Request for Information

Project: Sterile Processing Services – Construction

VA Sioux Falls Health Care – Sioux Falls, S.D.

RFQ: 36C77624R0115

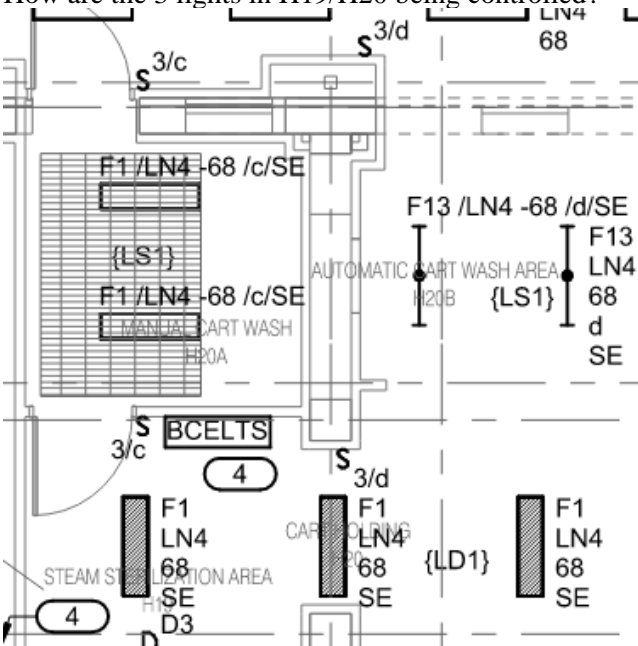
25.	<p>The plans show what looks like a new oxygen line but the piping is not bold like the other lines.</p> <p>Will there be a new 2" oxygen line?</p>	<p>The oxygen piping shown on PL100, PL101, PL111, along with all specified components and equipment, are included within the scope of the project.</p>
